ALLISON 1000 DURABILITY UPDATES FOR 2010

ALLISON 1000/2000 "6 SPEED"

2010 UPDATES

Figure 13

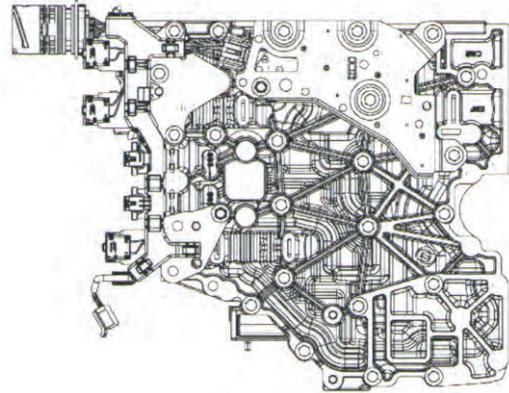
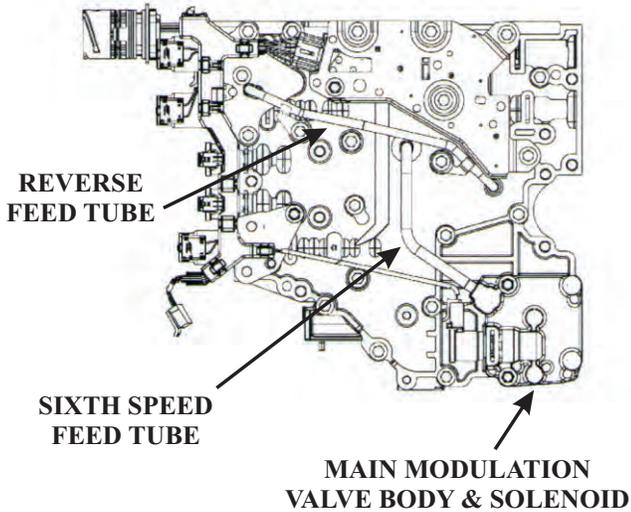
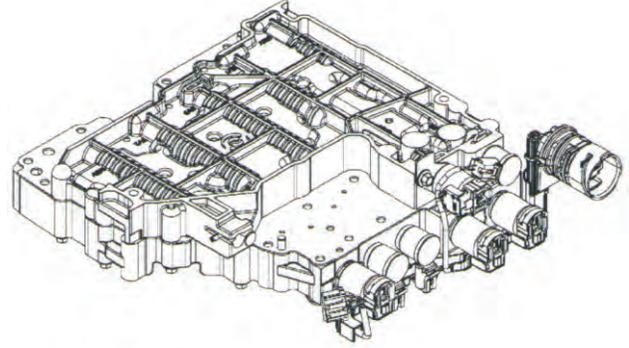
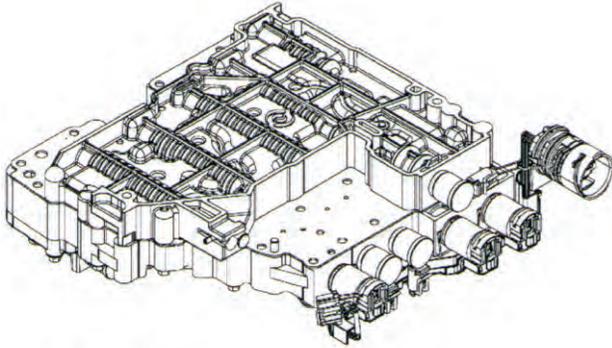
VALVE BODY

The Sixth Speed & Reverse Feed Tubes & Main Modulation Valve Body Are Eliminated. The Main Modulation Solenoid Has Been Relocated.

PRE-2010 UPDATE DESIGN

2010 UPDATE DESIGN
